RECORD DRAWINGS
 This drawing reflects changes from the original contract drawing that were made during construction and has been prepared from information provided to the Engineer by the construction contractor(s). The Engineer does not warrant this drawing to be complete and accurate in all respects.
 MALCOLM PIRNIE, INC.
 Date: 6/88 By: MGM

San Antonio
 WASTEWATER FACILITIES IMPROVEMENTS

CONTRACT NO. 3
DOS RIOS FACILITY
 PRIMARY SETTLING TANKS
 PLAN - TANKS NOS. 6 & 8

DR 83-6502

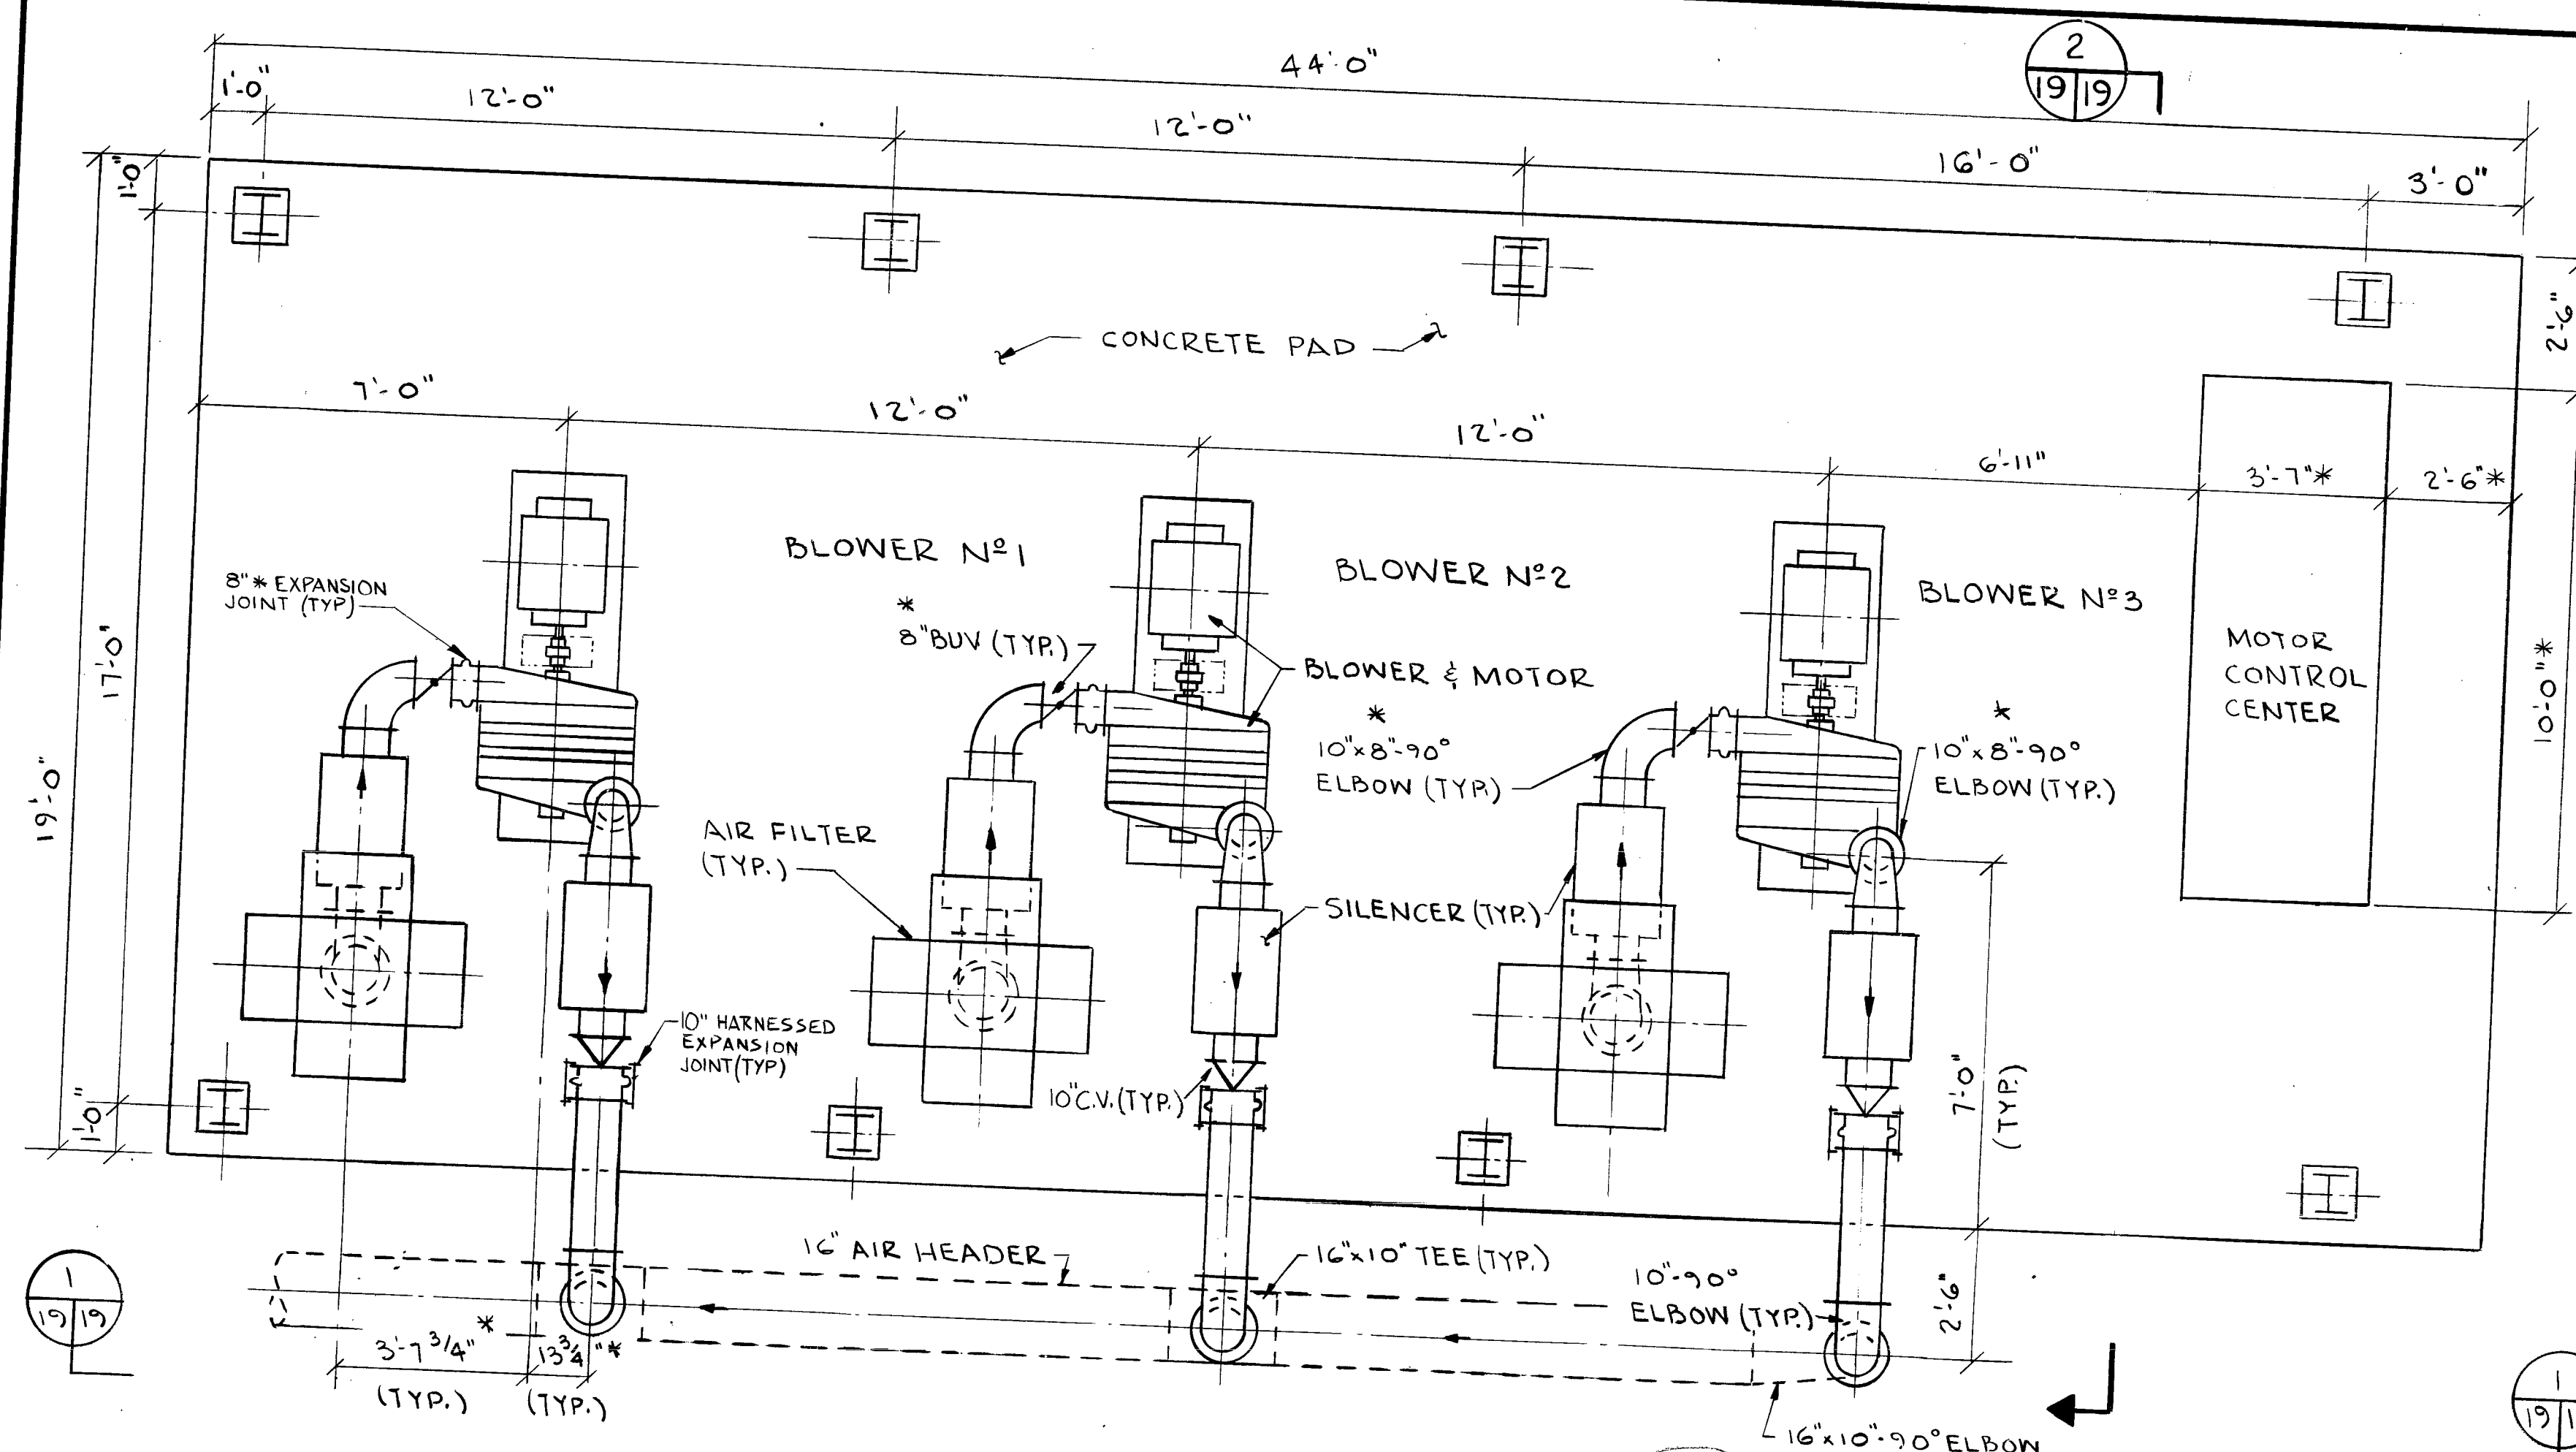
PIPE ELEVATIONS HAVE BEEN REVISED. REFER TO PCC DRAWING REF-1 FOR "AS-BUILT" CROSS REFERENCES.
